**Addendum i to
ASHRAE Guideline 36-2018**

Proposed Addendum i to Guideline 36- 2018, High-Performance Sequences of Operation for HVAC Systems

**First Public Review (November 2019)
(Draft shows Proposed Changes to Current Guideline)**

Figure 5.10.5 Control logic for variable-volume series fan-powered VAV zone.

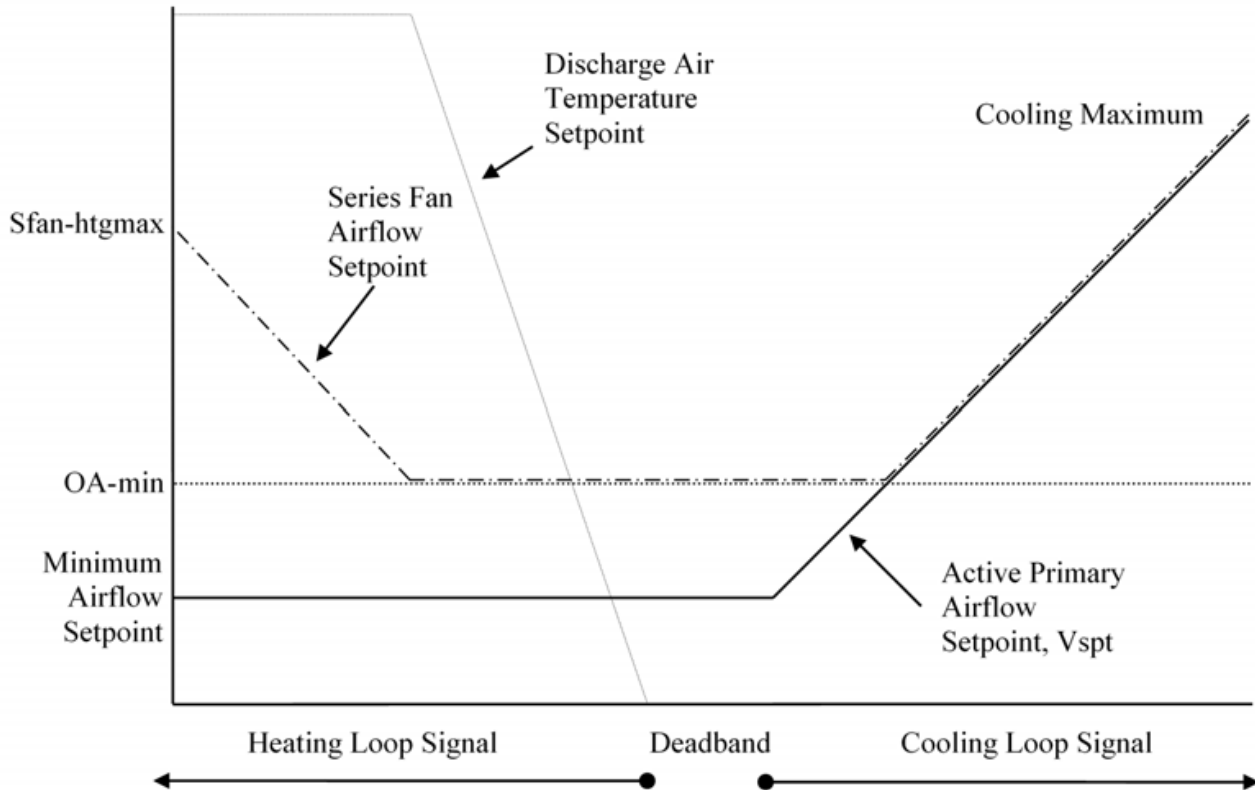
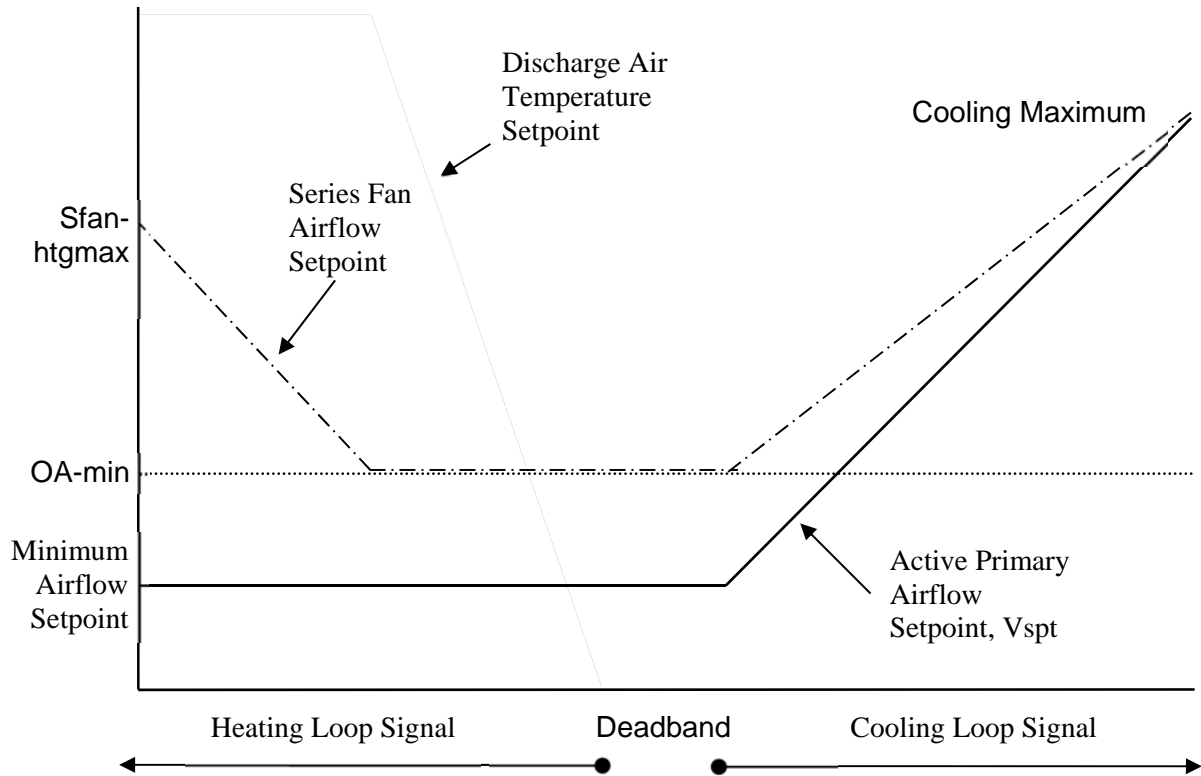
This addendum revises the way the variable speed series fan is controlled. Currently, the speed tracks the primary airflow. This revision maps the fan airflow setpoint from a minimum equal to the larger of the ventilation minimum and the primary airflow minimum, up to the cooling maximum. This intent is to help ensure that the fan airflow exceeds the primary airflow, so that no primary air exits the induction port into the return air plenum, recognizing that the actual fan airflow and actual primary airflow can vary from setpoint. Note that this will only be effective if the ventilation minimum is larger than the primary airflow minimum, as it will be if the designer is taking advantage of the indirect ventilation capability of the recirculated return air from other zones. If the ventilation minimum is the same as the primary airflow, the sequence is effectively the same as the current sequence.

Revise Figure 5.10.5 and Section 5.10.5.1 as follows:

1. The Cooling Loop output shall be mapped to the primary airflow setpoint from the cooling minimum to the cooling maximum airflow setpoints.
 - a. If supply air temperature from the air handler is greater than room temperature, primary airflow setpoint shall be no higher than the minimum and the series fan airflow setpoint shall be no higher than OA-min.
2. ~~The Cooling Loop output shall be mapped to the~~ The series fan airflow setpoint shall be the from the larger of OA-min and the primary airflow cooling minimum setpoint to the cooling maximum airflow setpoint.
3. Heating coil is off.
